Re: Florida Power & Light Company
Proposed Turkey Point Units 6 and 7
Docket Nos. 52-040 and 52-041
Response and Revised Response to NRC Request for Additional
Information Letter No. 082 (eRAI 7811) SRP Section
02.05.04 – Stability of Subsurface Materials and Foundations

Attachment 1: FPL Response to NRC RAI No. 02.05.04-26 (eRAI 7811)

NRC RAI Letter No. PTN-RAI-LTR-082

NRC RAI Number: 02.05.04-26 (eRAI 7811)

Figure 1 Primary Grout Borehole Layout

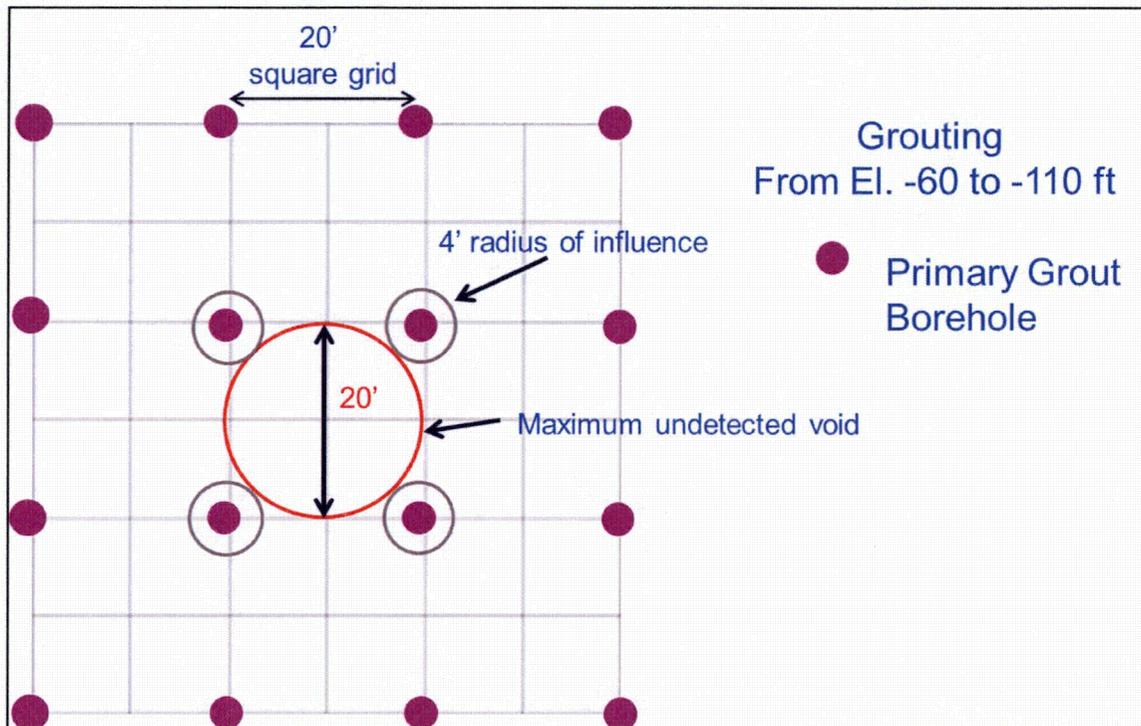
3. Additional details on the planned microgravity gravity survey specifically:
 - a. Address the size of the areas to be investigated
 - b. Will measurements be conducted along profiles or the entire excavated surfaces surveyed

4. A description of the type of inspection and test program to be followed to reasonably ensure that gravity anomalies resulting from potential underground voids (both within the grouted zones and deeper levels) that are critical to the stability of subsurface materials and the integrity of SSCs are to be appropriately detected, investigated, evaluated and, if necessary, remediated.

Instead of developing the critical void size via microgravity methods, which can only detect large voids at depth, the subsurface grouting program, which was planned only for dewatering purposes, will be considered in the determination of constrained void sizes. Part 4 of this response provides an Inspection, Tests, Analyses, and Acceptance Criteria (ITAAC) to ensure that the zone between El. -35 feet and El. -60 feet within the diaphragm walls will be grouted according to the closure criteria that will be developed as part of the grout test program. This grouting will ensure that any potential voids in this zone are filled. In addition, for the zone between El. -60 feet and -110 feet within the diaphragm walls, grouting will be performed in every primary grout borehole. Primary grout holes will be spaced less than or equal to 20 feet on center. This

configuration, as shown in Figure 1, is expected to constrain the maximum undetected void size to approximately 20 feet.

radius of influence of 4 feet, corresponds to a sphere shaped void with a maximum 20 feet equivalent diameter (as shown in Figure 1).

Figure 11 Plastic Points PLAXIS3D (Static Loading)

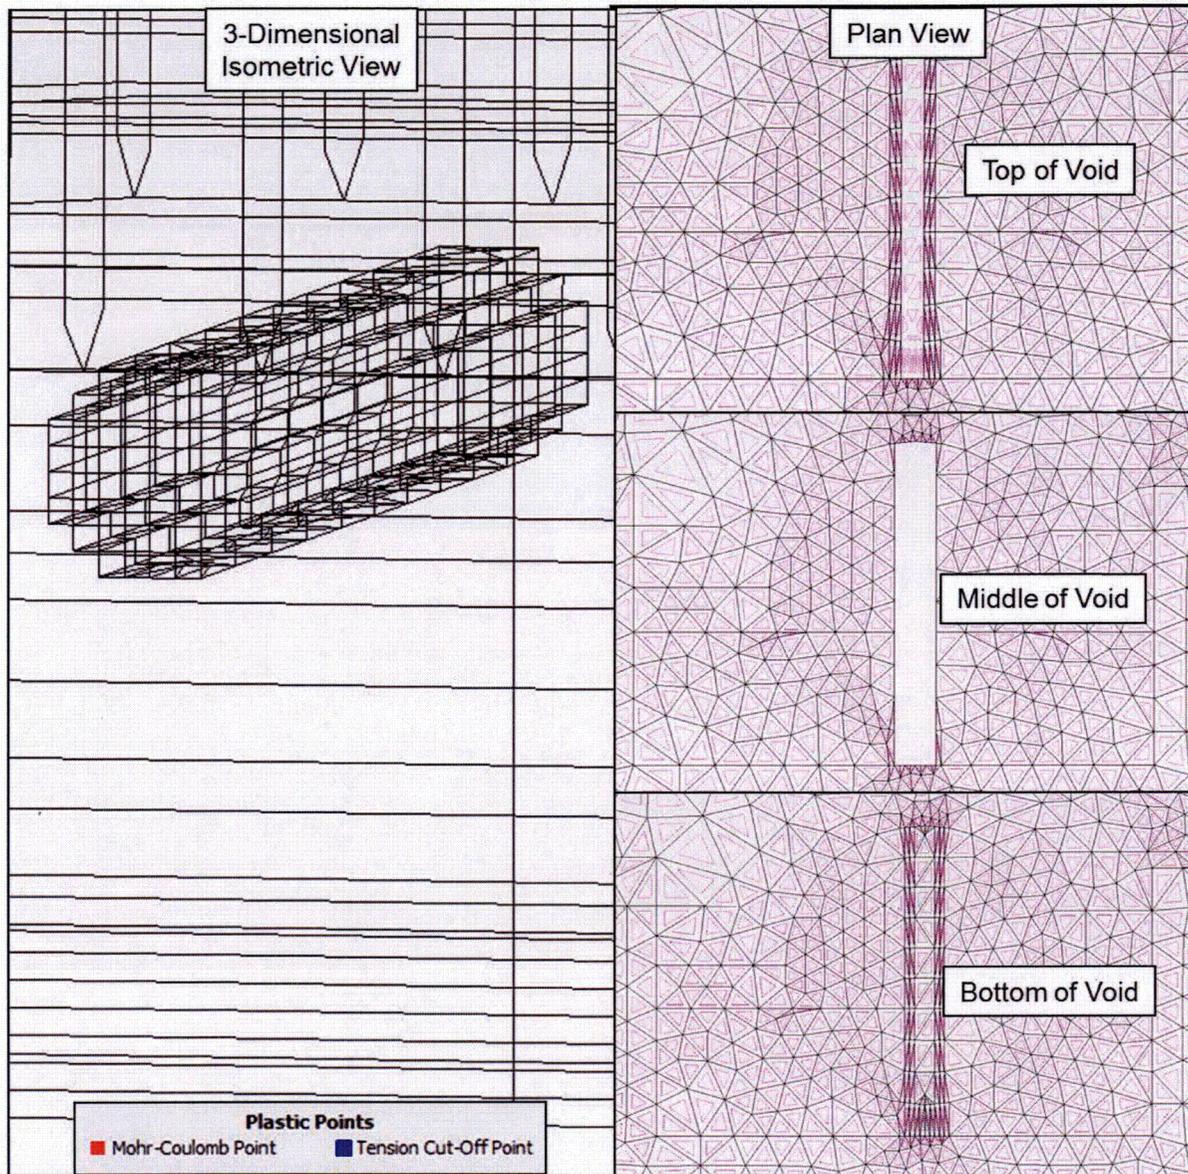
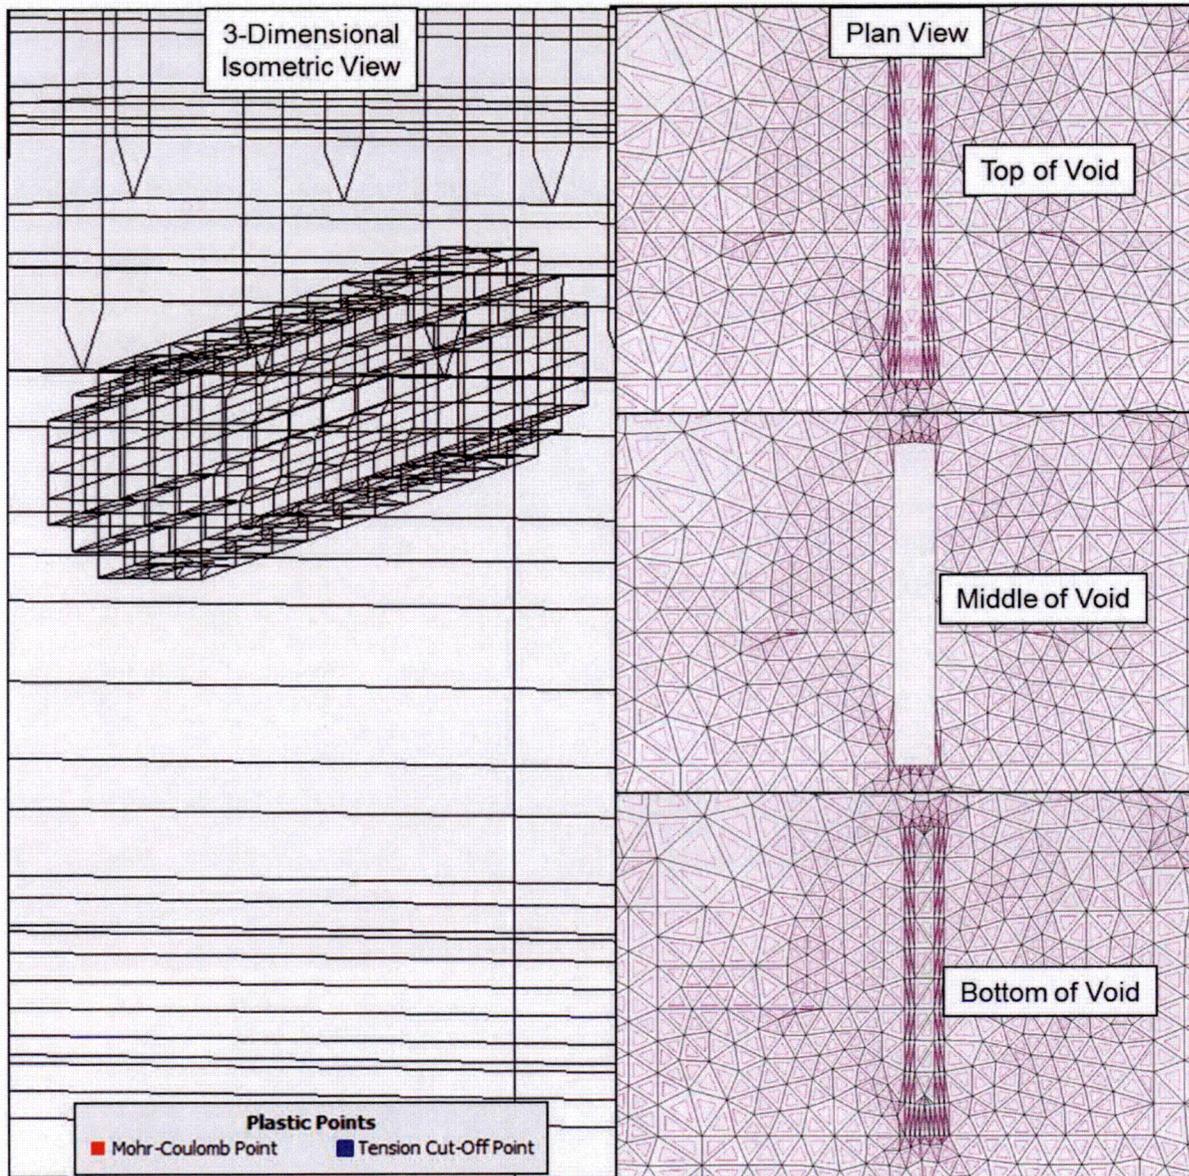
1. Clarification and demonstration that only the voids greater than the 25-foot spherical diameter and/or 12-foot cylindrical diameter at an elevation of about -60 feet are critical to the stability of subsurface materials and the integrity of structures, systems, and components (SSCs).

Yield at any point is considered to occur if the stress state reaches the Mohr-Coulomb failure envelope. As shown in Figure 11, there are no plastic points (indicated by red squares) or tension cut-off points (indicated by blue squares) near the void location indicating that the rock mass surrounding the void is not experiencing compressive failure according to Mohr-Coulomb failure envelope or points where the tensile load exceeds the tensile capacity. No tension cut-off points are identified within the concrete fill, i.e., the tension in the concrete fill is less than the tensile capacity of the concrete fill.

Yield at any point is considered to occur if the stress state reaches the Mohr-Coulomb failure envelope. As shown in Figure 2.5.4-274, there are no plastic points or tension cut-off points near the void location indicating that the rock mass surrounding the void is not experiencing compressive failure according to Mohr-Coulomb failure envelope or points where the tensile load exceeds the tensile capacity. No tension cut-off points are identified within the concrete fill,

Figure 1 Shear Wave Velocity Profile

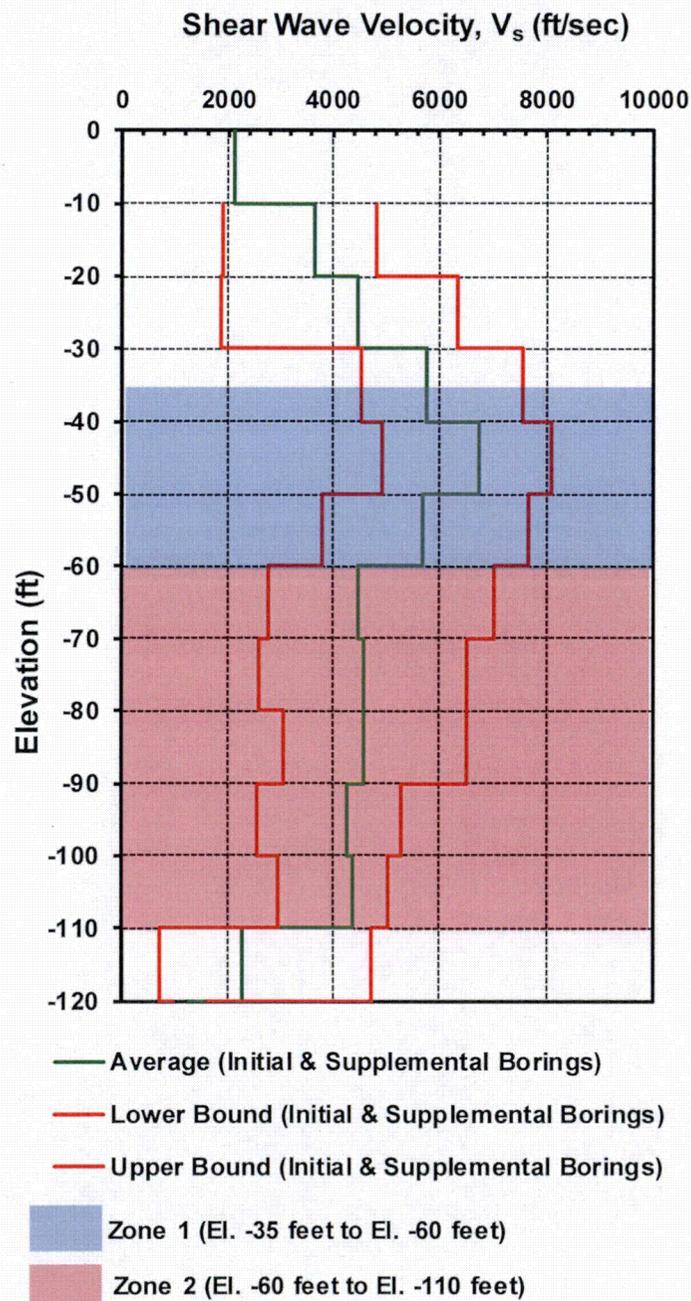
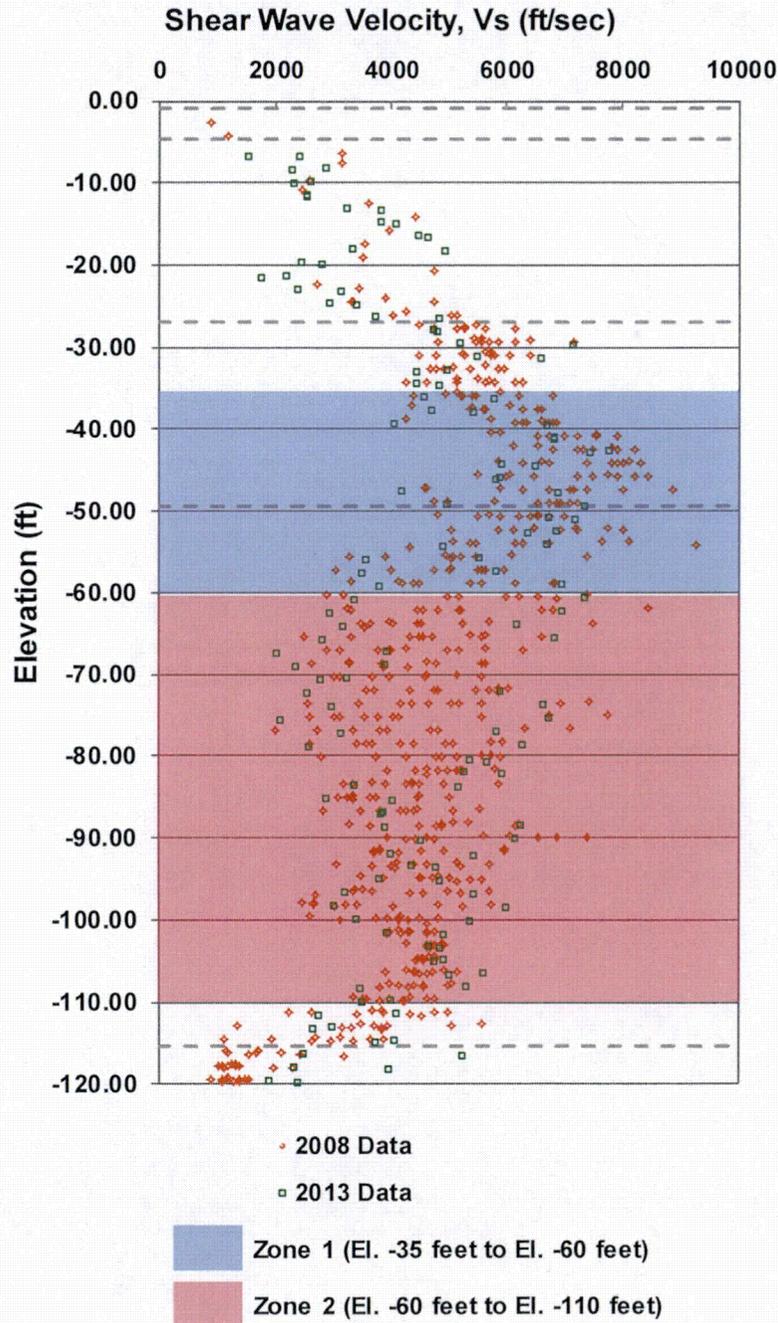
FSAR Subsection 2.5.4.5.4 states that grouting will be conducted beneath the nuclear island between the elevations of approximately -35ft and -60 ft to form a grout plug for construction related groundwater control. In accordance with 10 CFR 100.23 and RG 1.208, please describe what inspection and test programs will be conducted for ensuring the shear wave velocity post grouting is consistent with the shear wave velocity used in the site response analyses you performed in your previous calculation of the GMRS in FSAR Subsection 2.5.2.6.

The grouted zone (Zone 1) between El. -35 feet and El. -60 feet encompasses approximately 14 feet of the Key Largo Limestone Formation (average top El. -27 feet) and approximately 11 feet of the Fort Thompson Formation (average top El. -49.4 feet). This zone shows the shear wave velocity profiles ranging from approximately 4000 ft/s to 8000 ft/s, as seen on Figures 1 and 2.

As described in the Response to RAI 02.05.04-26, primary grout boreholes will be drilled and pressure grouted between El. -60 feet and -110 feet to constrain the size of postulated voids in the Fort Thompson Formation below Zone 1. The extended zone (Zone 2) between El. -60 feet and -110 feet shows the shear wave velocity profiles ranging from approximately 2500 ft/s to 7000 ft/s, as seen on Figures 1 and 2.
